Comment Letter I76

McClellan-Palomar Airport PEIR & Master Plan Feedback

Response to Letter I76**Richard Breyer**

Table 2.5-1. Trip Generation

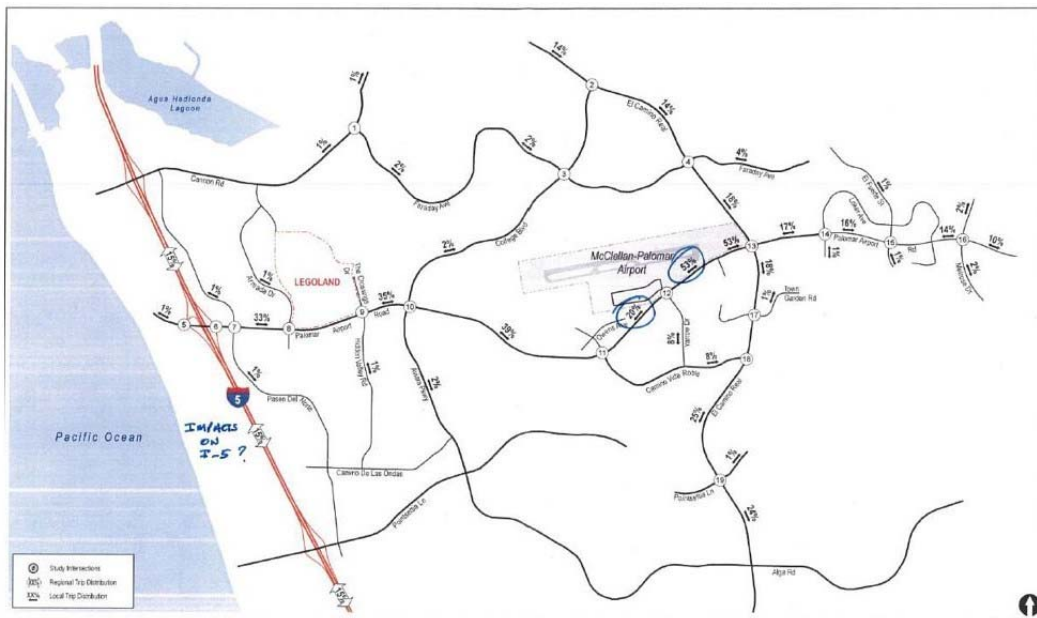
9. I have included below 2 attachments that need to be corrected. Both have errors that need to be corrected and that data needs to be included in your revised DPEIR for circulation and further review. 176-11

ERROR

- I76-13** This comment includes an image of the Draft PEIR Table 2.5-1 Trip Generation in which the PAL 2 ADT Volume is circled and marked with "error." The County agrees this is a typographical error as it was copied incorrectly from the Appendix E Transportation Impact Analysis. This corresponding table from the Transportation Impact Analysis identifies the correct ADT Volume of 4,206. The PEIR Table 2.5-1 has been corrected. As this was a typographical error, it does not change the PEIR's findings or conclusions.

**Project Traffic Distribution
Figure 2.5-2**

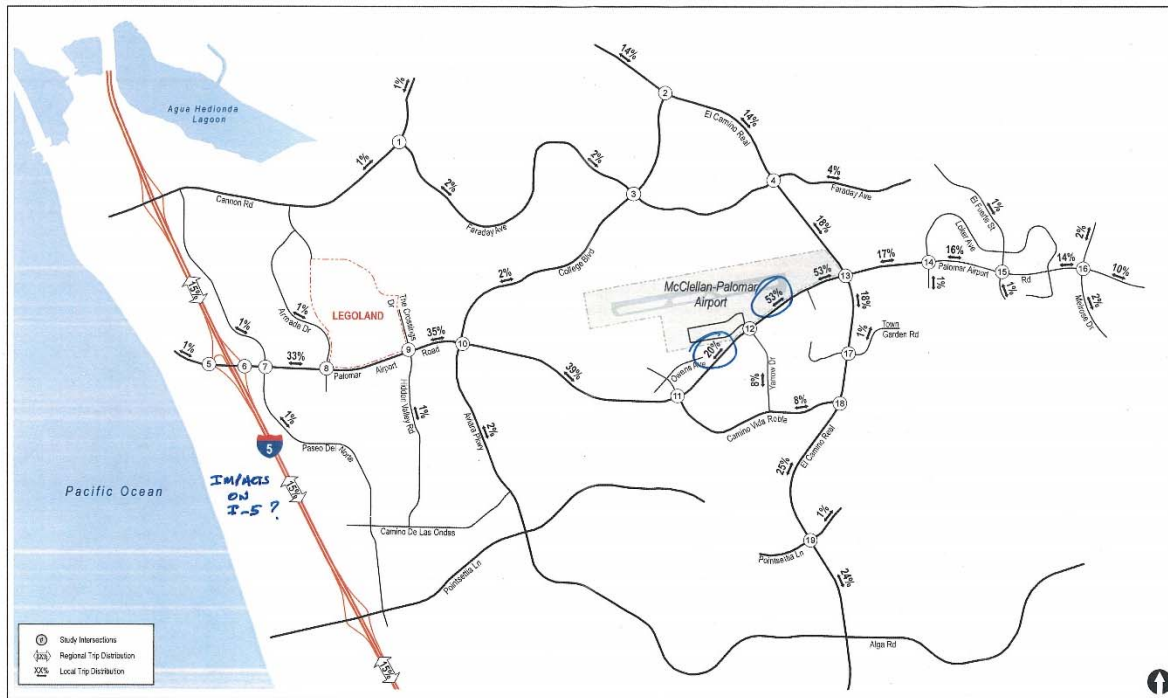
10. See Figure 2.5-2 attached
11. See Table 2.5-1 Trip Generation attached
12. Why are the future impacts to I-5 Freeway that this Airport expansion will have not addressed in this DPEIR?

- I76-14** This comment includes an image of the Draft PEIR Figure 2.5-2 Project Traffic Distribution in which the commenter circled the project's percent distributions along Palomar Airport Road on either side of Yarrow Drive. After another review of these percentages, the traffic technical expert verified the percentages are correct, and the County is unclear what error the commenter is referring to since no narrative description was provided. However, upon further review of Figure 2.5-2, additional information was added to clarify the project's percent distribution from the main entrance at Yarrow Drive (81%) and the project's percent distribution from the secondary entrance at Owens Avenue (19%). No other changes to the PEIR have been made in response to this comment.

On Figure 2.5-2, the commenter also wrote, "impacts on I-5?" Please see **Response to Comments I76-7 and I76-12**.
